Village of Grantsburg

Village Board Meeting Agenda Monday, February 9, 2026 at 4:00 p.m. Village Board Room, 316 S. Brad Street

RE: Change Order 01
Village of Grantsburg
Grantsburg WWTP Improvements
SEH No. 184139 71.50

Change Order No. 1 to the Grantsburg WWTP Improvements project is enclosed. This Change Order includes six (6) items previously approved as individual line items by the Village Board and two (2) items that have not been approved. SEH recommends approval of Change Order No. 1 to incorporate the following changes into the Contract with Market & Johnson, Inc. (Contractor):

REVISION SCHEDULE		
REV. #	DESCRIPTION	DATE
1	CB 01	09/03/2025

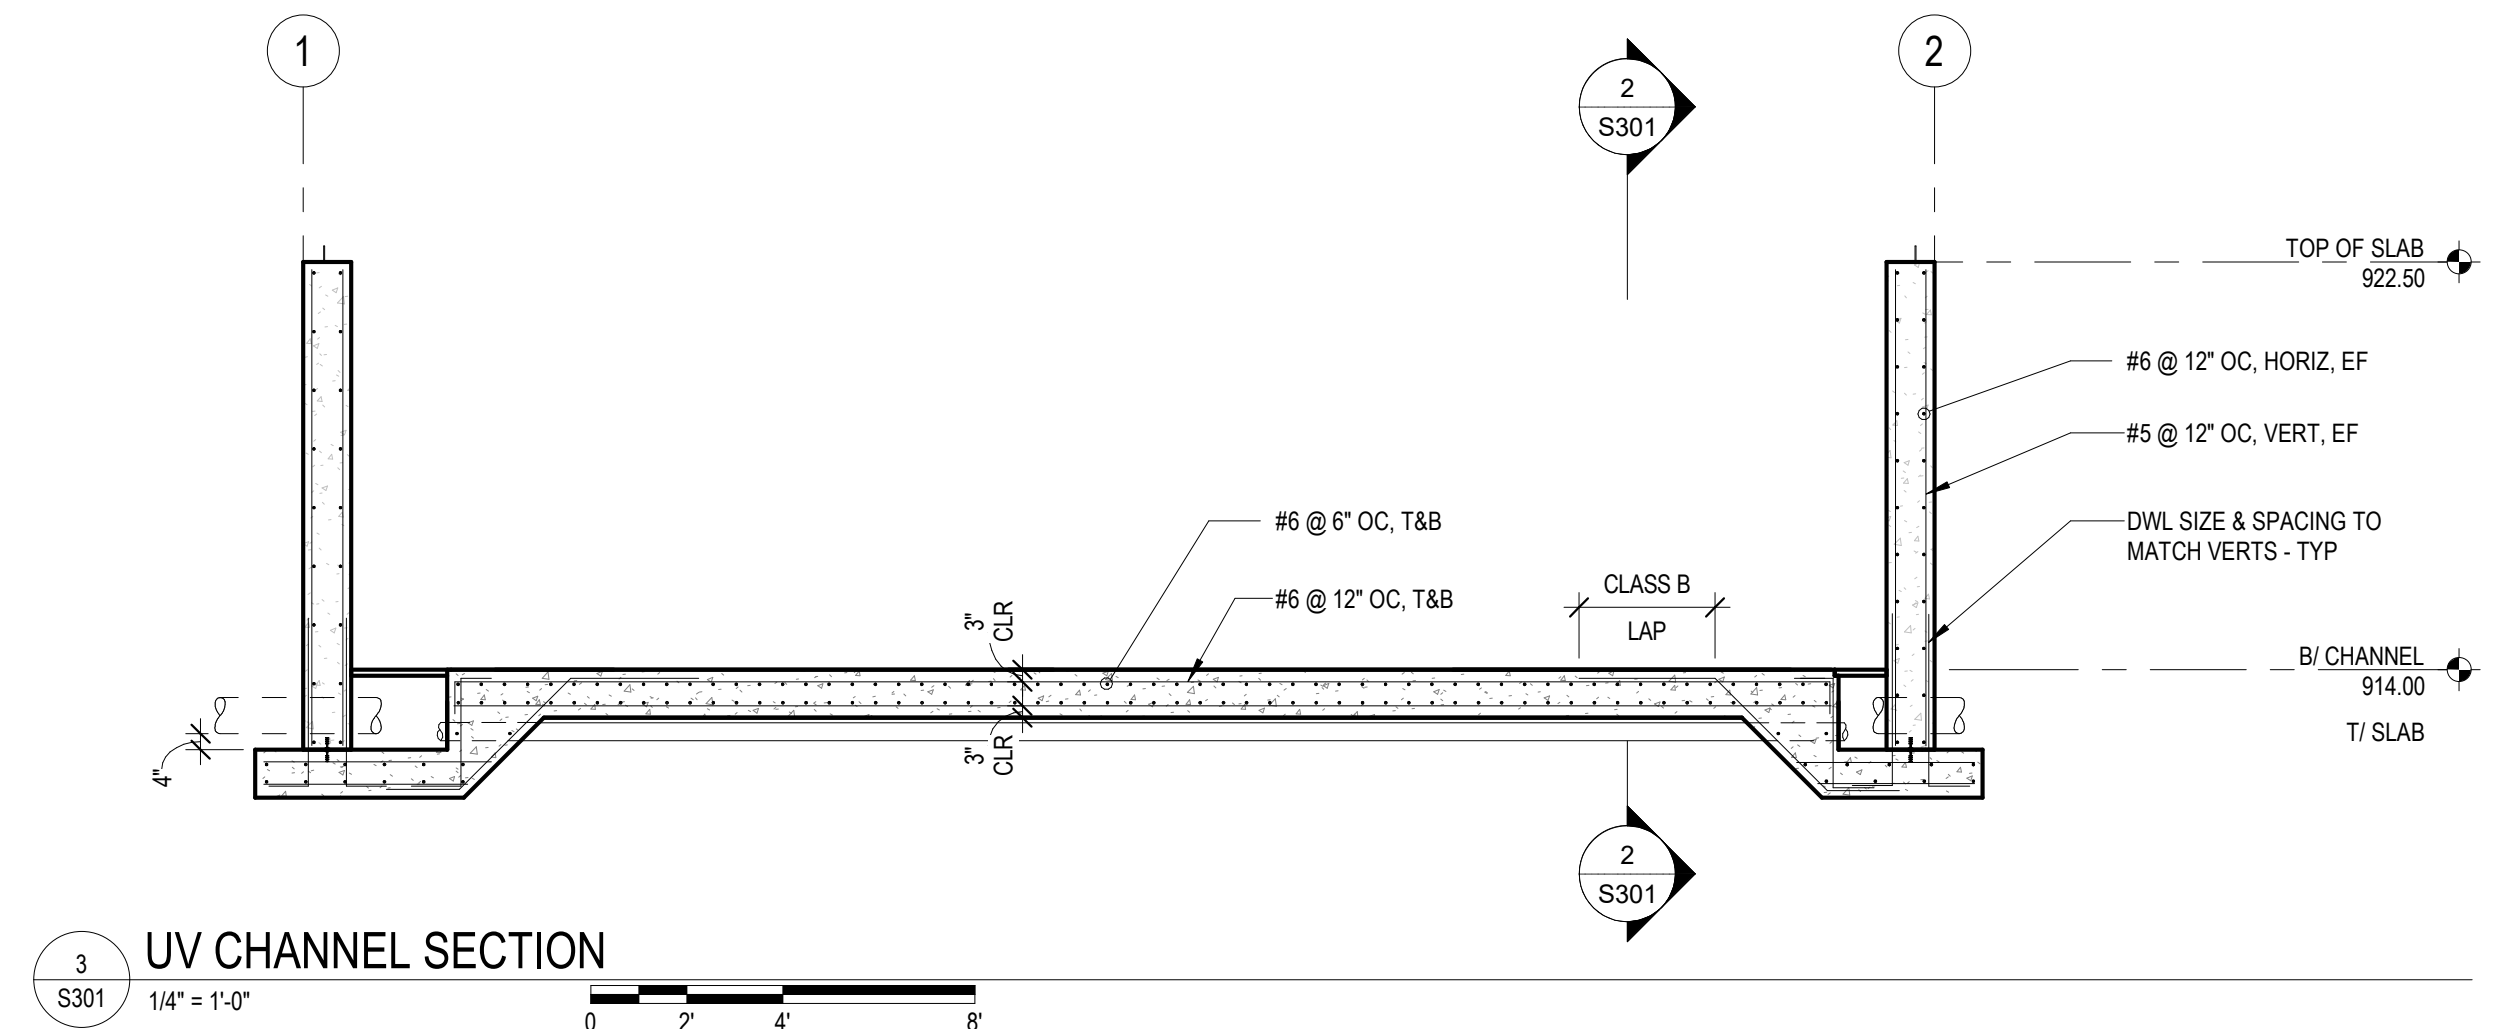
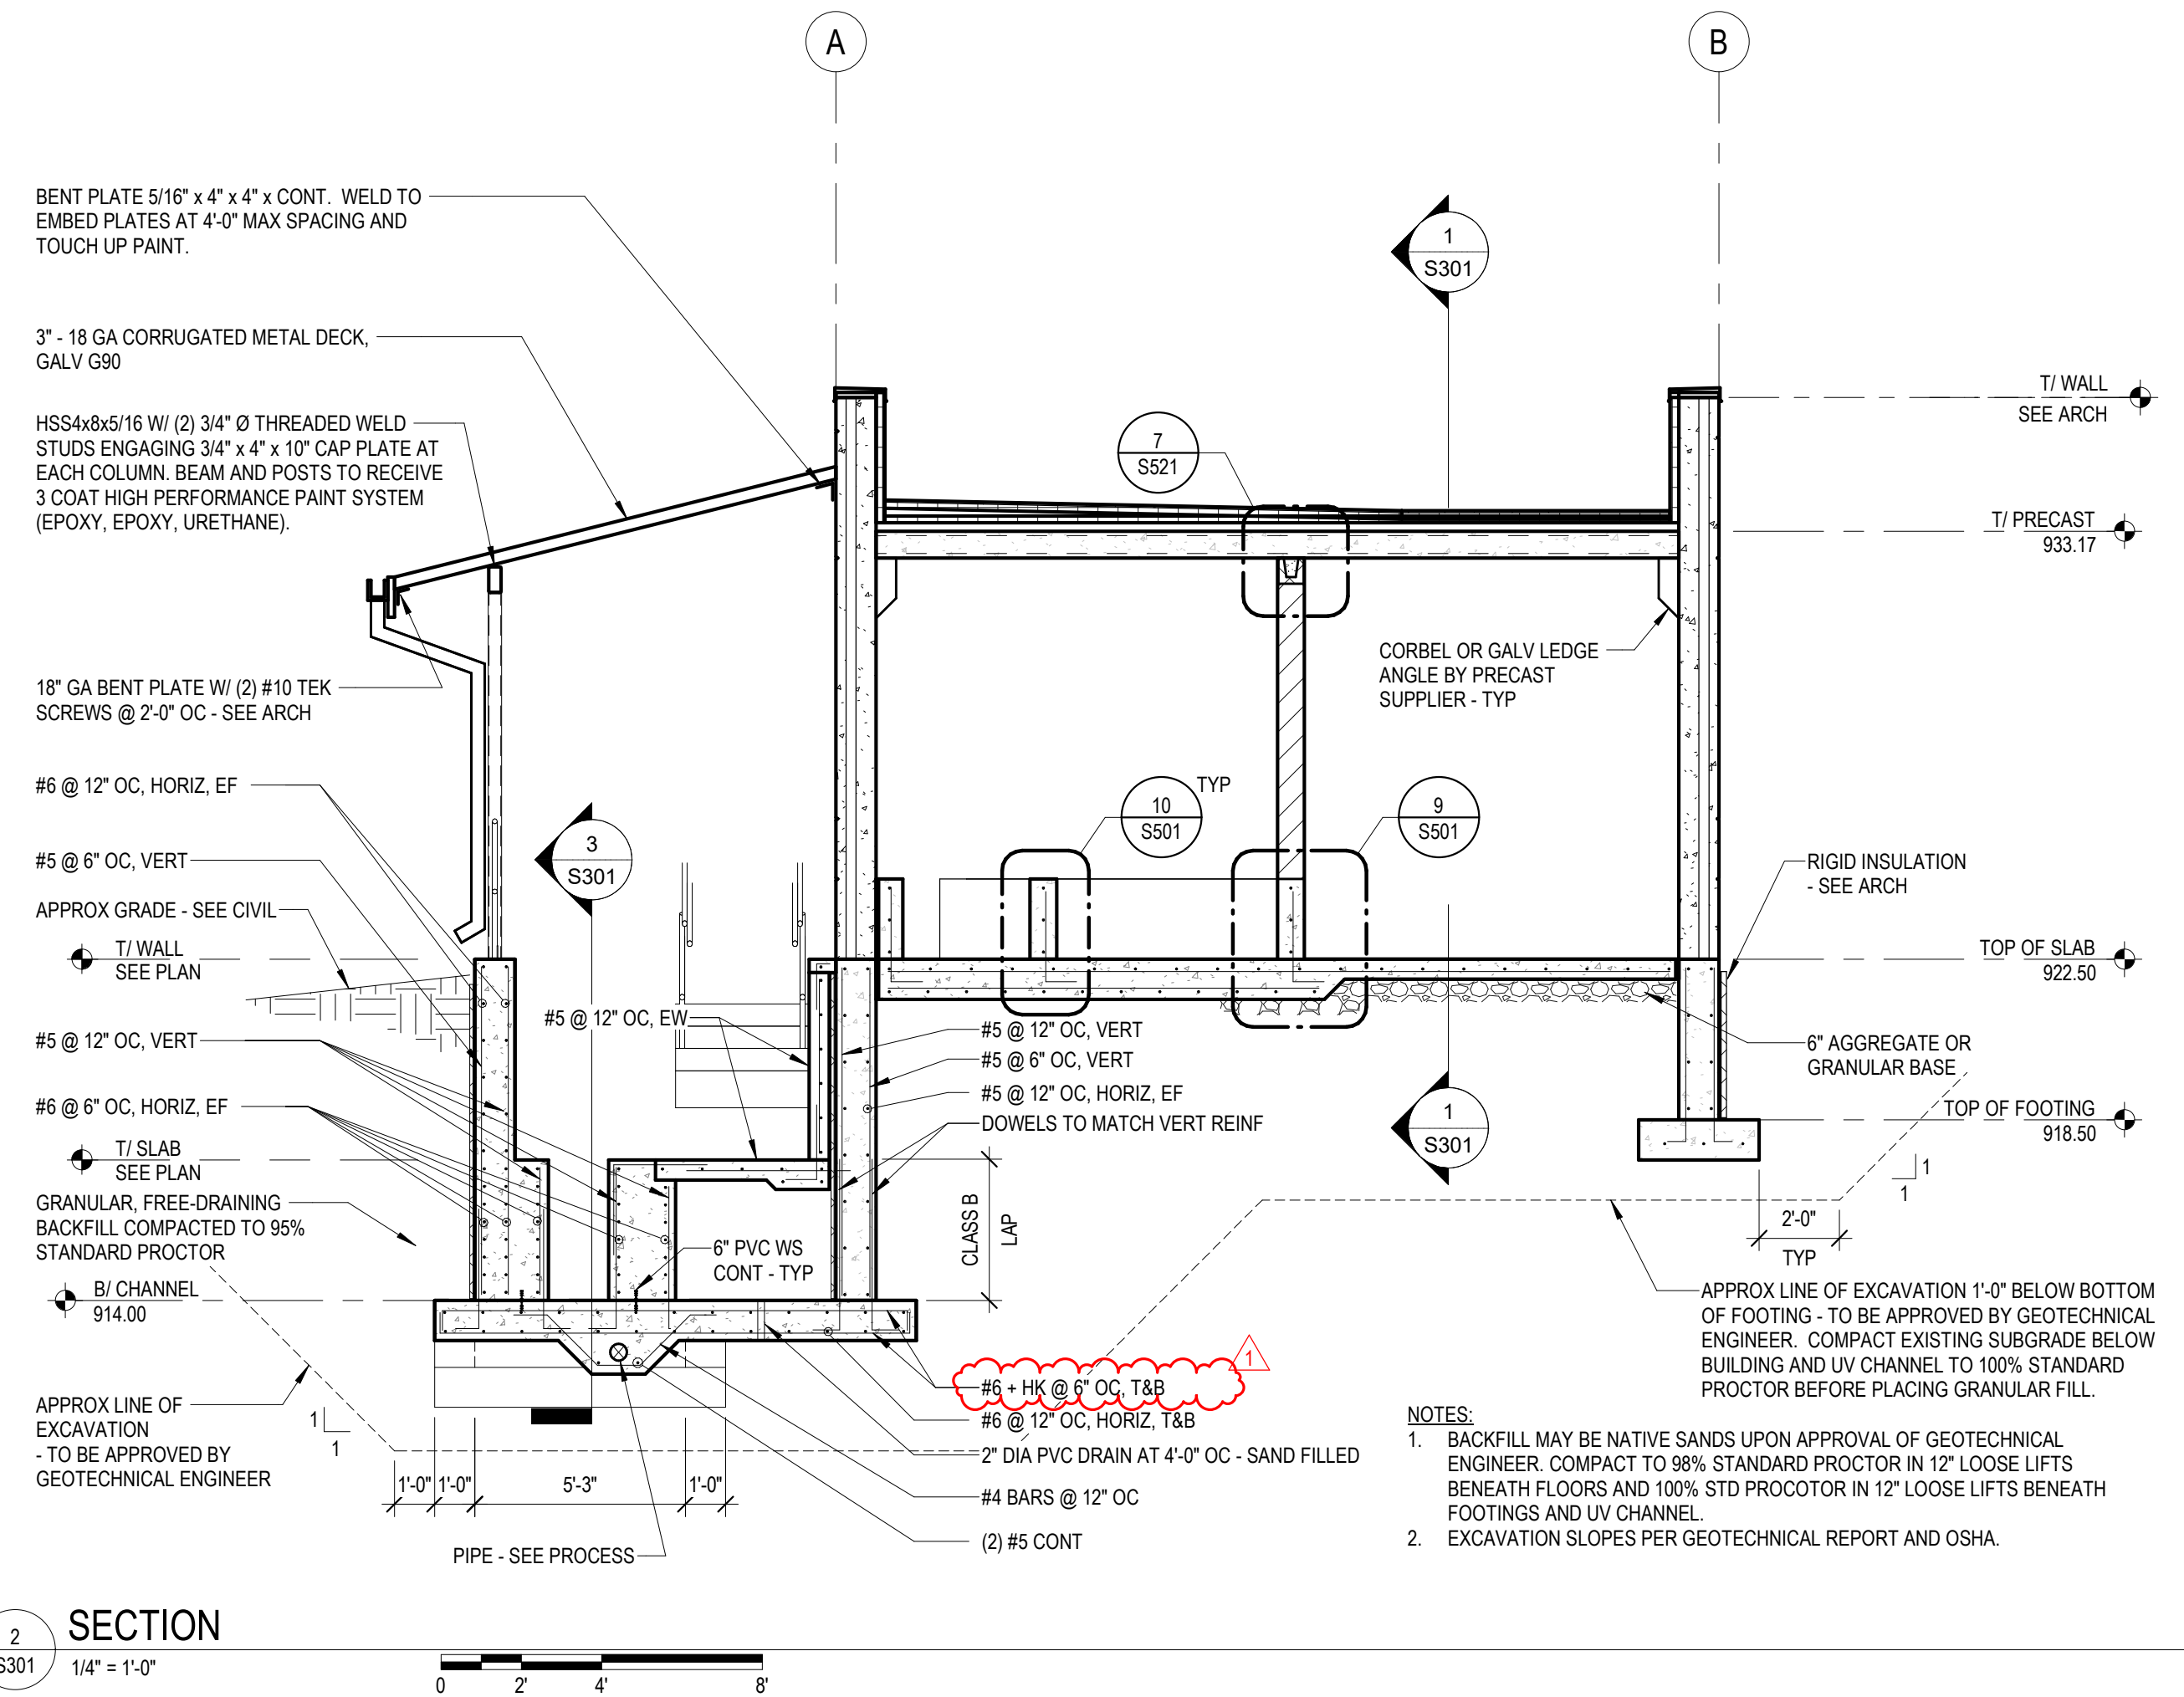
This Construction Bulletin (CB-01) documents drawing revisions and clarifications identified during the structural shop drawing reviews (rebar and precast). These changes were noted on the returned shop drawings and consolidated here for the record.

The purpose of this Construction Bulletin is to formally communicate several drawing changes associated with discrepancies discovered during the structural shop drawing reviews for rebar and precast. These drawing changes/clarifications have already been communicated on the returned shop drawings. No cost changes associated with this Construction Bulletin.
